BMW Motorrad USA Service Information Bulletin

****Notice of Recall 09V-319****

Subject: Replacement of the fuel-pump electronics

Model: R 1200 GS (K25), R 1200 GS Adventure (K25/02), R 1200 GS facelift (K25/11), R 1200 GS Adventure facelift (K25/12)

Illustration: Fuel-pump electronics before (large image on right) and after spraying with protective-Wax-Spray (small image on left); this example shows the R 1200 GS facelift (K25/11).

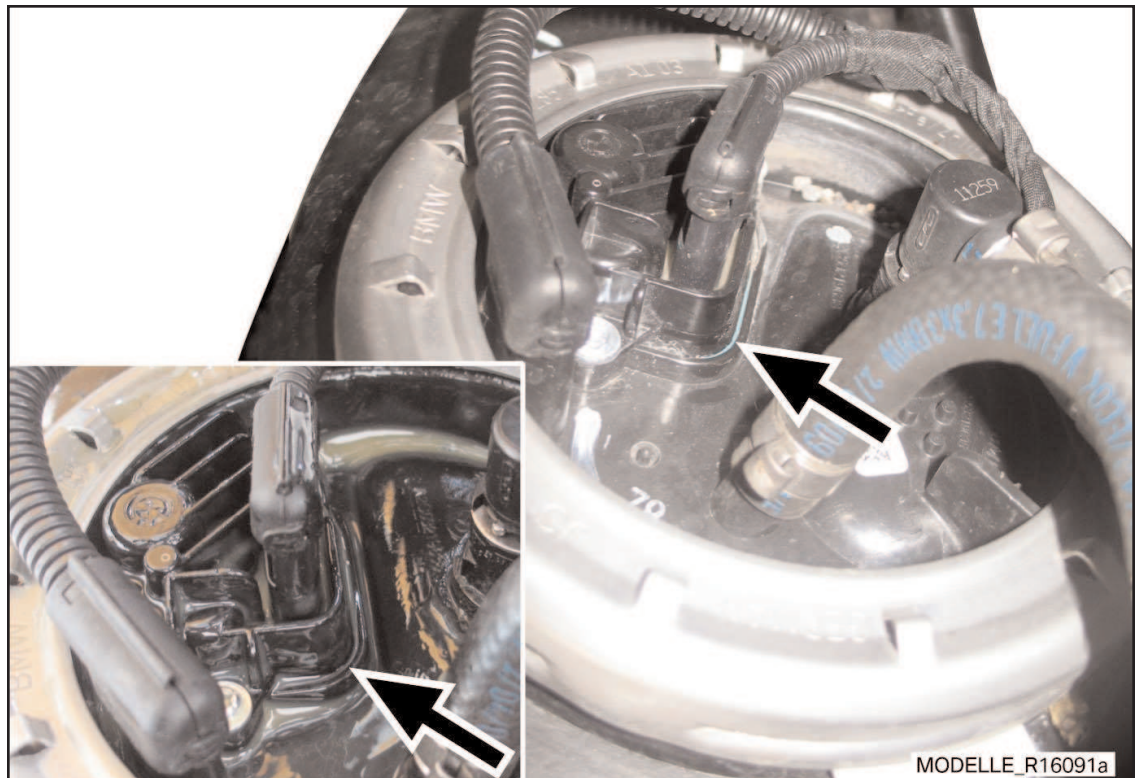
Finishing work: In order to ensure a 100% seal after replacement, the sealing area around the fuel-pump electronics (between fuel-pump electronics and fuel-pump flange) must be sprayed with a protective-wax spray i.e Wurth Protective Wax, (see arrows in the illustration below).
